UNITED STATES  
 NUCLEAR REGULATORY COMMISSION  
 REGION V  
 1450 MARIA LANE, SUITE 210  
 WALNUT CREEK, CALIFORNIA 94596

SUBJECT: SOUTHERN CALIFORNIA EDISON COMPANY, SAN ONOFRE UNIT 3  
 DOCKET NO. 50-362

REGION V COMMENTS ON DRAFT LICENSE FOR SAN ONOFRE UNIT 3

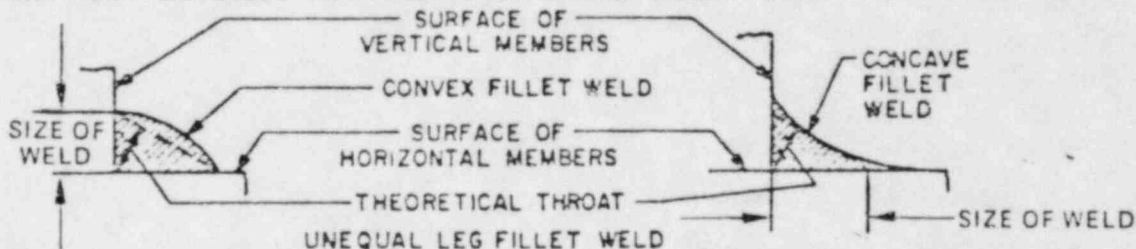
The ASME Code, Section III, Subsection NF, Subarticle NF-4427, "Shape and size of fillet welds," states that, "Fillet welds may vary from convex to concave. The size of the fillet weld shall be determined in accordance with figure NF-4427-1." Figure NF-4427-1 depicts what actually constitutes the weld size depending on whether the weld is concave, convex, or of unequal leg size. Discussions with Bechtel engineers indicated that weld convexity is self limiting by the nature and type of weld process used and will not cause significant stress concentrations to be produced at the weld. Also, ASME Code Interpretation No. III-80-109, Question (1), in reply to whether NF provides requirements for the maximum convexity of fillet welds, states that NF does not address this subject.

FIG. NB-4233-1 BUTTWELD ALIGNMENT TOLERANCES AND ACCEPTABLE SLOPES FOR UNEQUAL I.D. AND O.D. WHEN INSIDE SURFACE IS INACCESSIBLE FOR WELDING OR FAIRING

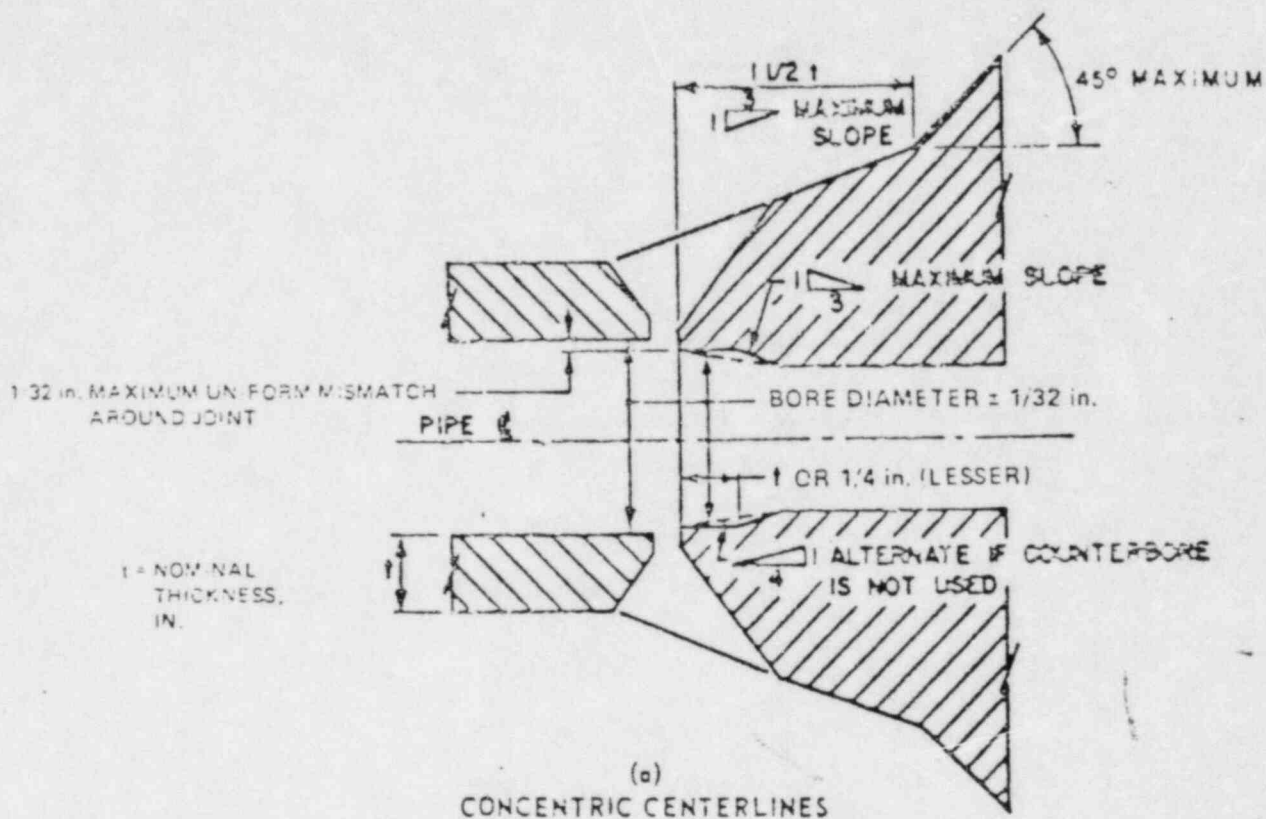
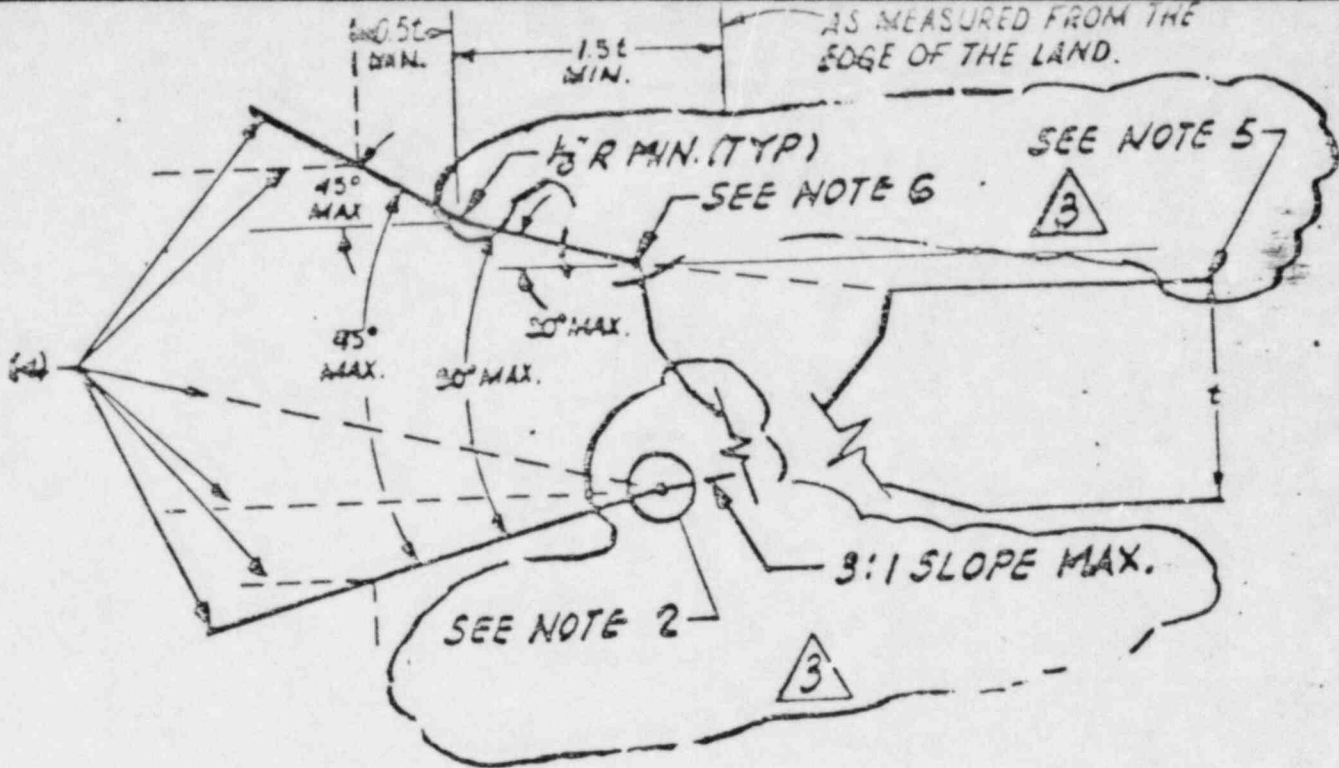
Regarding the low and high pressure safety injection systems, the licensee's commitment, contained in the FSAR, is to the 1974 Edition of the ASME B&PV Code, through Summer 1975 addendum. The Code, Figure NC-4233-1, requires that a taper of 1 in rise to 3 in run be provided for a distance of 1.5 times the nominal pipe wall thickness between the 45° maximum slope section on the valve and the pipe/weld junction attaching the pipe to the valve. Similar figures exist in the 1974 ASME Code, Sections NB and ND.

On November 12, 1982, a copy of Figure NB-4250-1 was received at Region V from the allegor. The copy received was duplicated from the 1980 Edition of the ASME B&PV Code, Division 1, Section III, Subsection NB. As mentioned previously, the licensee is committed to the 1974 Edition of the ASME B&PV Code. The valve to pipe welds questioned by the allegor are governed by Subsection NC of the 1974 Code and not by Subsection NB.

The inspector examined the manufacturer's detail drawings for the above valves in question and examined the distances from the 45° maximum transition in the field. These distances were compared with the requirements of Figure NC-4233-1 of the ASME B&PV Code, 1974 Edition.

Based upon these examinations the inspector concluded that the maximum slope (3:1 taper) requirements of the Code were complied with on each field installation in question. Further, the inspector verified that the actual slopes encountered in the field more closely approached 4:1 taper and thus were more conservative than the Code required maximum of 3:1.

The inspector examined the drawing copy supplied by the allegor and concluded that the Code required 3:1 taper requirements were complied with on the two valve to pipe welds questioned by the allegor.
